# Extraordinary Meeting of Council

2 July 2025

Item 5.1		<ul> <li>- 24 Gibraltar Street Bungendore - Demolition of Existing Building Medical Centre</li> </ul>	and
	Attachment 1	Plans - DA.2025.0014 - 24 Gibraltar Street, Bungendore	2
	Attachment 2	Perspectives - DA.2025.0014 - 24 Gibraltar Street, Bungendore1	3
	Attachment 3	Landscape Plan - DA.2025.0014 - 24 Gibraltar Street, Bungendore1	6
	Attachment 4	Pre-Demolition Hazardous Survey Report - DA.2025.0014 - 24 Gibraltar Street, Bungendore1	8
	Attachment 5	Section 4.15 Table - Matters for Consideration DA.2025.0014 - 24 Gibraltar Street, Bungendore	37
	Attachment 6	Draft Conditions of Consent - DA.2025.0014 - 24 Gibraltar Street, Bungendore7	2

- ITEM 5.1 DA.2025.0014 24 GIBRALTAR STREET BUNGENDORE -DEMOLITION OF EXISTING BUILDING AND CONSTRUCTION OF MEDICAL CENTRE
- ATTACHMENT 1 PLANS DA.2025.0014 24 GIBRALTAR STREET, BUNGENDORE

Water and Sewer Services Plan - 24 Gibraltar Street, Bungendore

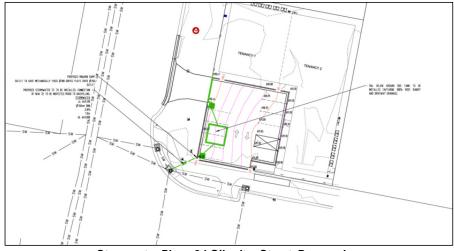
The proposed lot does not appear to have a stormwater connection to the Council mains. The proposed Stormwater plan indicates the installation of a  $150 \text{mm} \emptyset$  main from the southwest corner of the lot to the stormwater pit at the corner of Gibraltar Street and Ellendon Street.

As the proposed development will increase the impervious areas, an on-site detention storage system will be required to reduce the flow to predevelopment peak discharge rates of AEPs of 10% and 1% as per Council's D5 Stormwater Drainage Design Specification. A 13kl below-ground On-Site Detention (OSD) system is proposed as part of the development. The DRAINS model submitted as part of the development application suggested that the tank size is adequate to comply with QPRC D5 Specifications. The submitted plan indicated the OSD tank's approximate location on the carpark near the lot's southwest corner.
